CITY OF ALBUQUERQUE

October 5, 2020

RE: **Lot 2 Block 6 Unit 18 SAD 228
7828 Urraca NW
Volcano Cliffs Subdivision
Grading and Drainage Plan
Engineers Stamp Date 10/1/2020 (D10D003F22)**

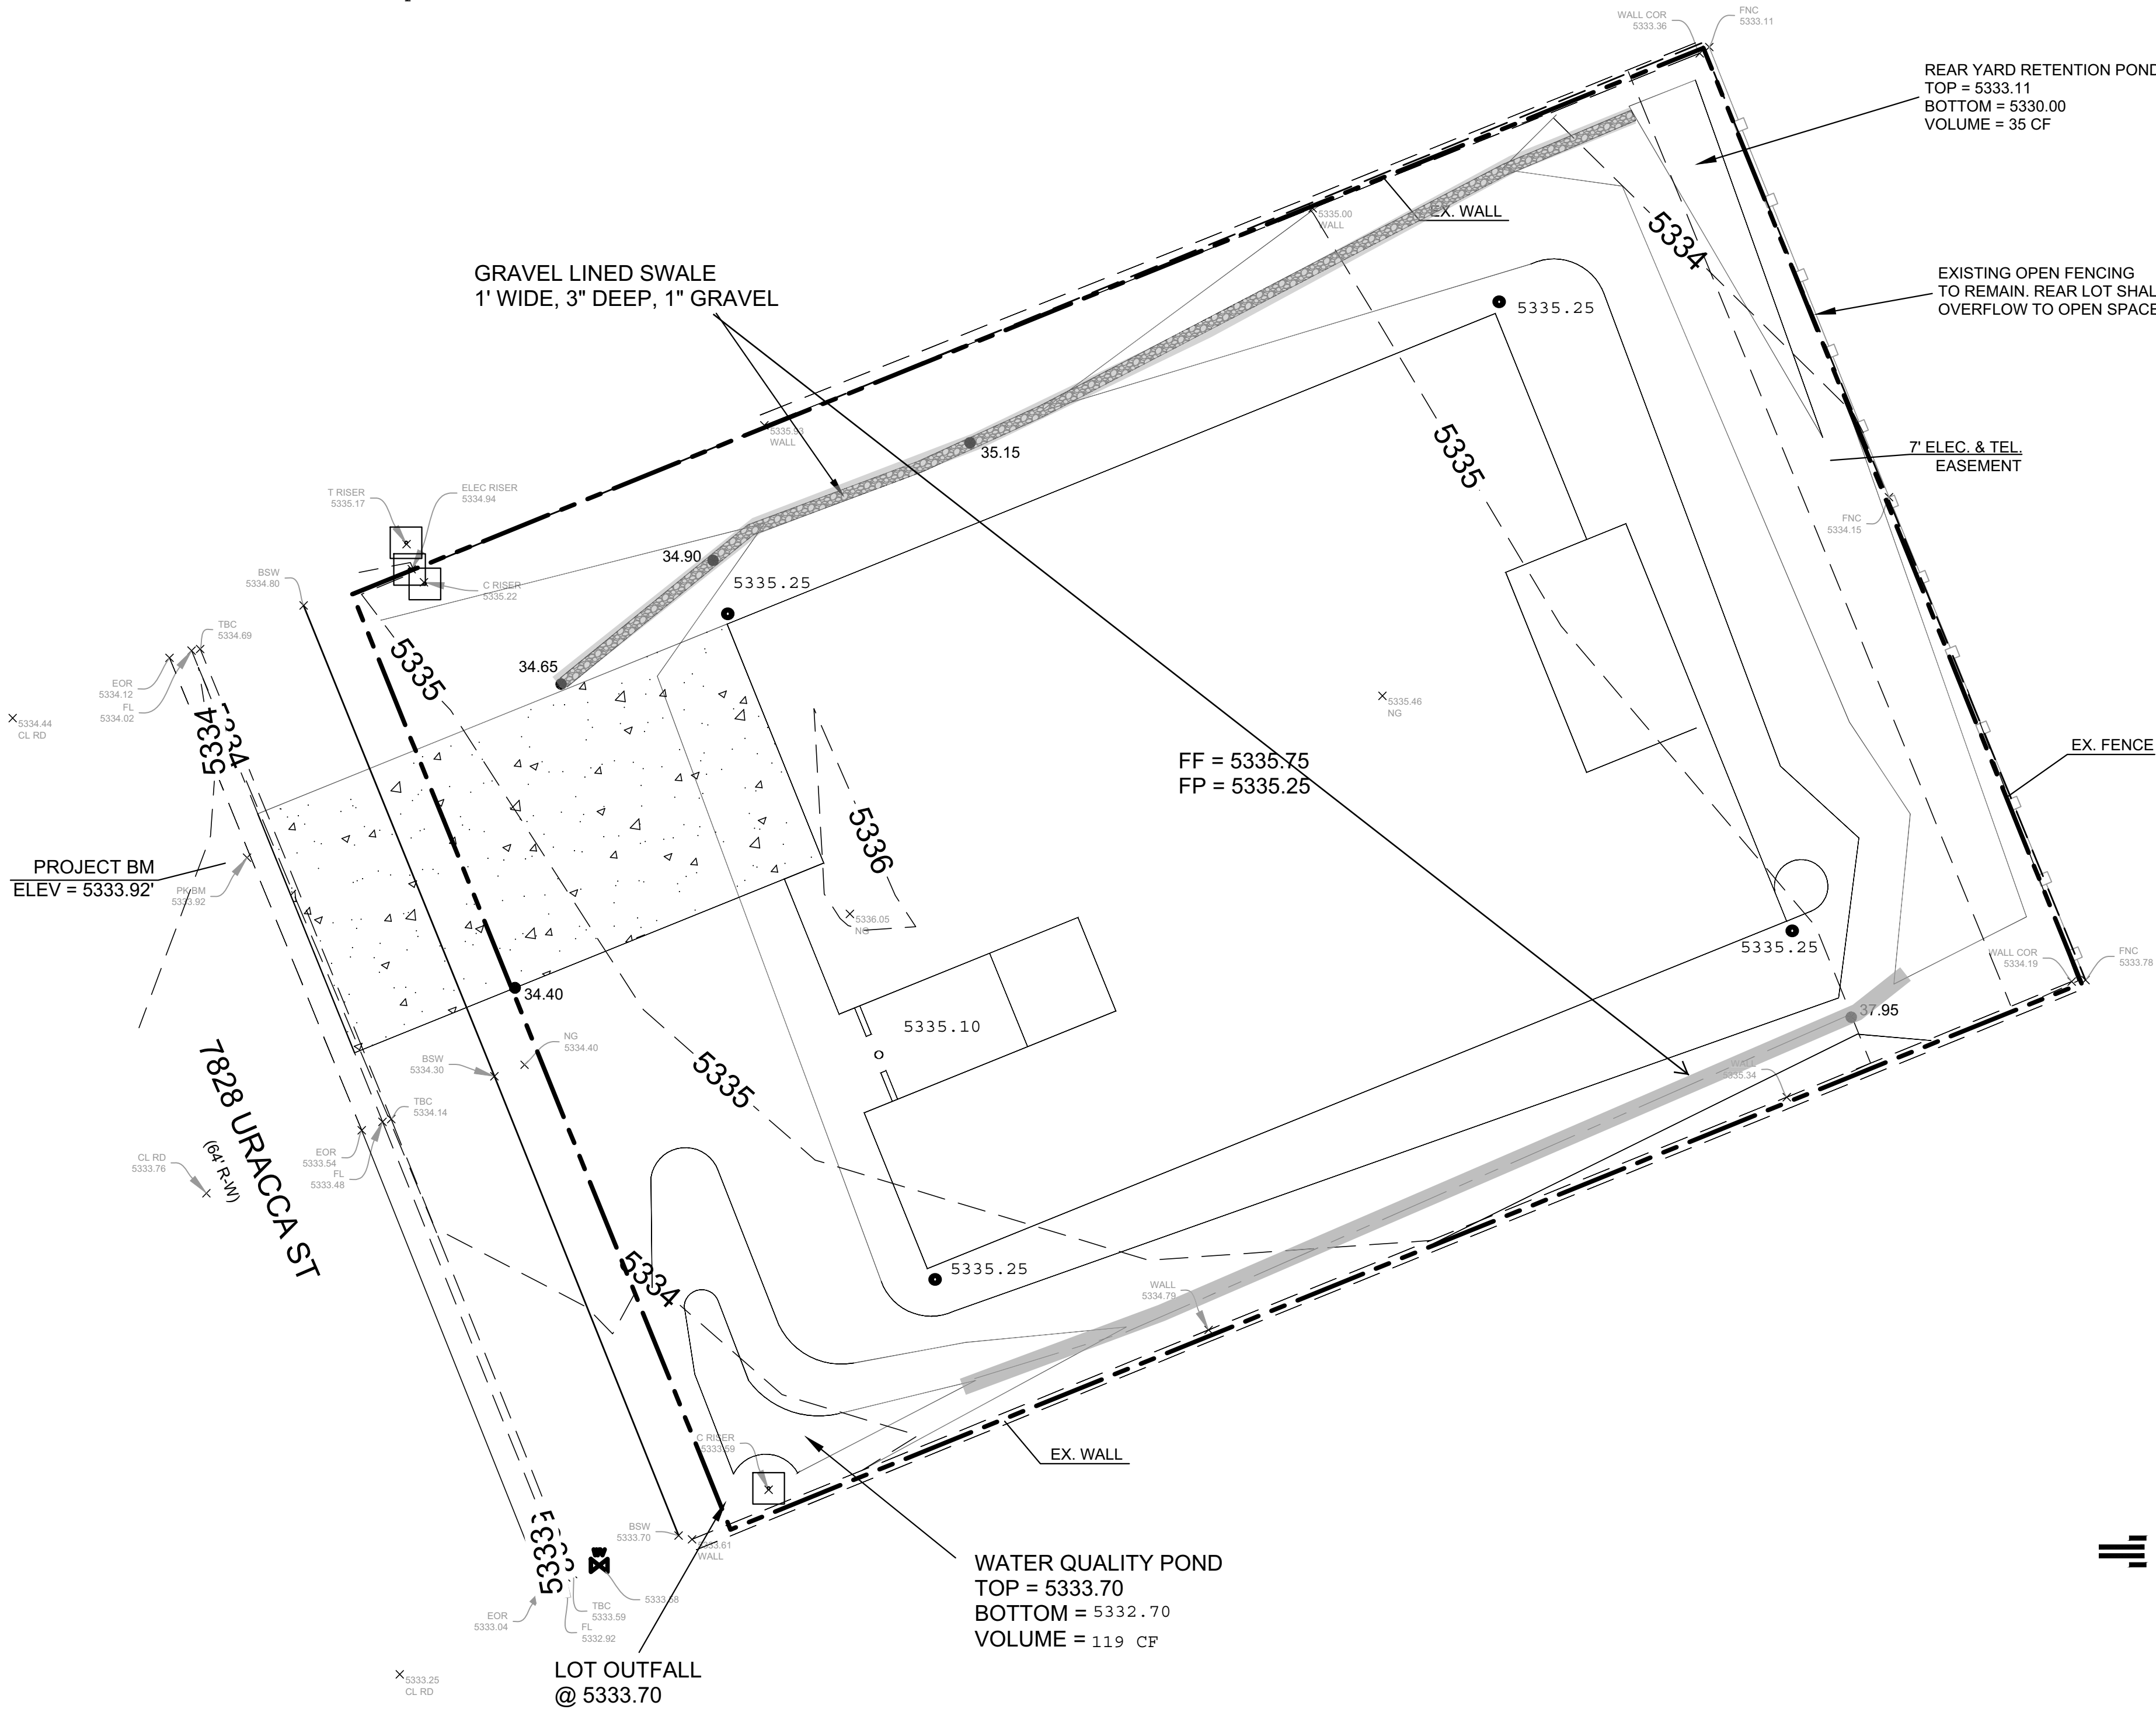
Prior to Building permit approval a Pad Certification will be required, provided by the Engineer or a registered Land Surveyor.

Advise the owner contractor not to use dirt as a ramp to climb the curb, use lumber or crusher fines for this purpose.

Reiterate to the Owner/Contractor that a separate permit for a garden/retaining wall must be obtained with the approved G&D plan and Pad Certification. Also, if a swimming pool is to be placed the grading and drainage plan will change and will need to be resubmitted.

Prior to Certificate of Occupancy release, Engineer Certification per the DPM checklist is required.
